CONTRACT CHANGE ORDER NO. _____
SHEET ____ OF ____

SAN FRANCISCO OAKLAND BAY BRIDGE
EAST SPAN SEISMIC SAFETY PROJECT

BRIDGE NO. 34-0006L/R
KILOMETER POST 13.9/14.3, 0.0/2.7
OAKLAND APPROACH STRUCTURES CLEANUP ITEMS
HANDRAIL ADJUSTABILITY DETAILS

TYPICAL EXISTING POST BASEPLATE

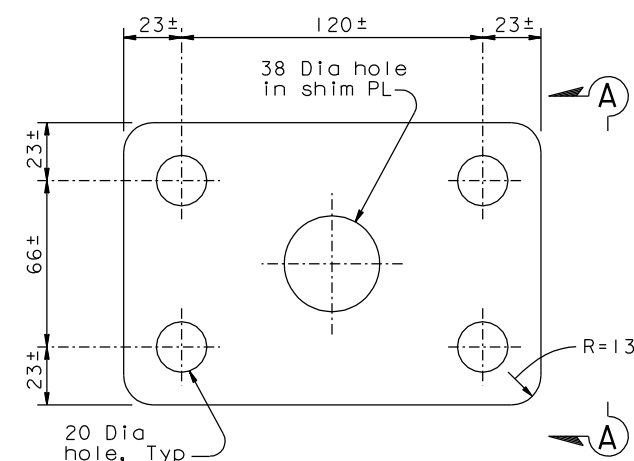
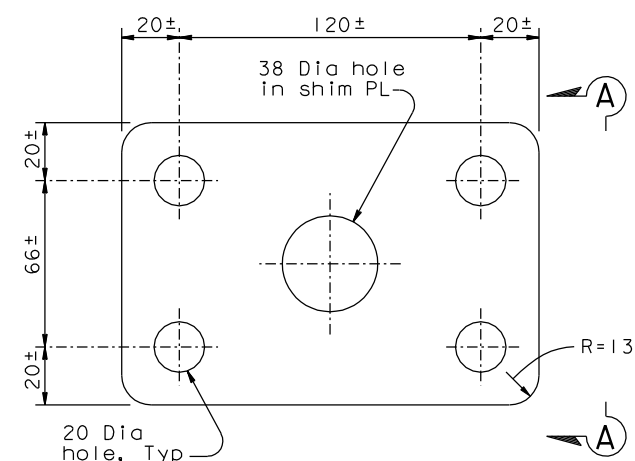
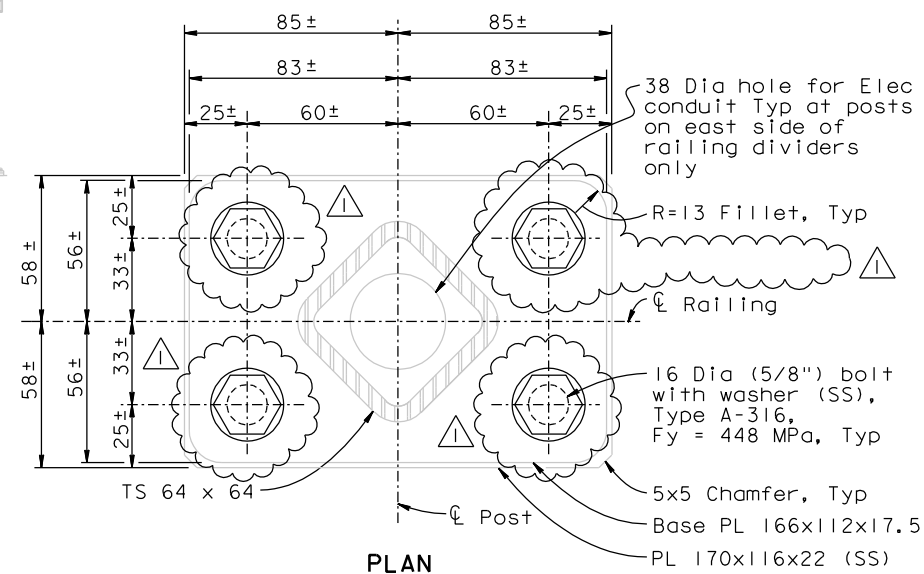
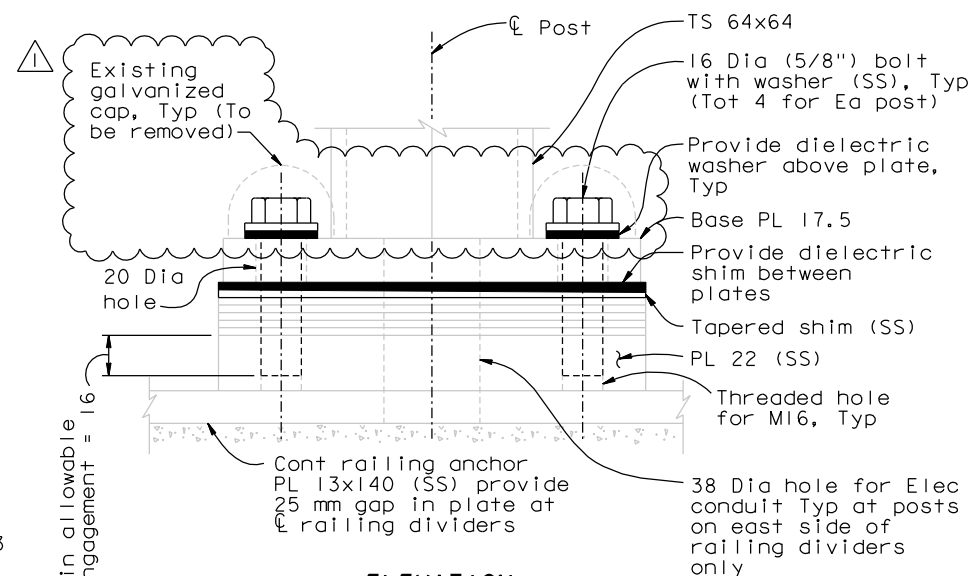
BOLT AND SHIM REPLACEMENT PROCEDURE:

1. Remove and discard bolt, cap and washer.
2. Remove and discard the dielectric material above and below the base plate.
3. Clean out and dry the threaded anchor hole.
4. If needed, replace the top most existing stainless steel standard shim with a new stainless steel tapered shim of thickness and taper necessary to properly align top rail of bikepath railing.
5. Install dielectric shim (UHMW) below base plate.
6. Install dielectric washer (UHMW) above base plate.
7. Insert new bolt and washer. The length of the bolt shall be such that the engagement length into the PL 22 is a minimum of 16 mm.
8. Bolts shall be tightened to "Snug Tight Plus 1/4 Turn". Bolts shall be installed with thread locking compound.
